Private Owner Circular Letter 663 Issue- Ia

Screw coupling failure.

POCL 663

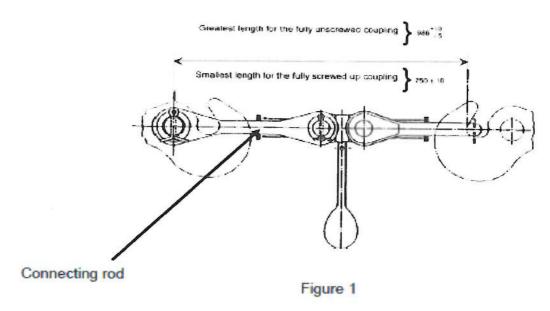
Inspect the screw coupling to identify if it is the correct type. The most effective way to do this is to measure the depth of section at the centre of the connecting rod. See figs 1, 2, & 3.

INCORRECT COUPLING	CORRECT COUPLING	
Rating 34.5 tonne	Rating 56 tonne	
Drawing B1-C0-9029821 item 06 to UIC 520 (see Appendices A to C)	Drawing B1-C0-9029821 item 05 or C1-A2-9000275 (see Appendices A to C)	
Connecting Rod size 35 to 42mm (see figure 3)	Connecting Rod size 52 to 55mm (see figure 3)	
Either no stamping marks or as per example photographs shown in Appendix D	May be stamped BR or 122T

2. Any screw couplings found to be the incorrect type must be renewed as a complete assembly. Note: the incorrect coupling may be of lower grade steel than the correct version therefore if replacement is required then the entire assembly must be replaced.

Figure 3

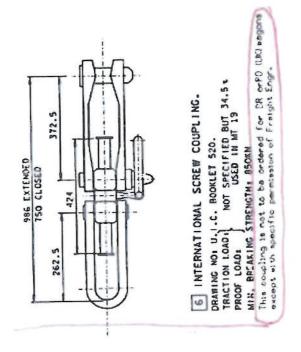
Connecting Rod Dimension to Check (Correct version shown)

## Appendix A- extract from drawing B1-C0-9029821

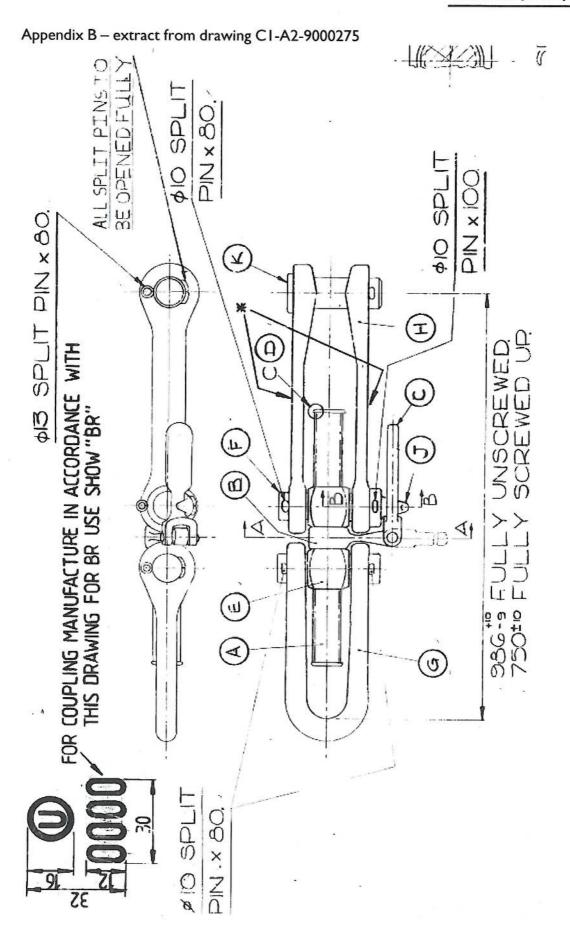
DRAWING NO. CI-AZ-9000275 GPR COUPLING.
CRAWING NO. CI-AZ-9000275 GPR CAI NO. 73.7290
(B.R.DESIGN) SUPERSEDES R.C.H.2827
TRACTION LOAD: 56 t
PROOF LOAD: 71 t
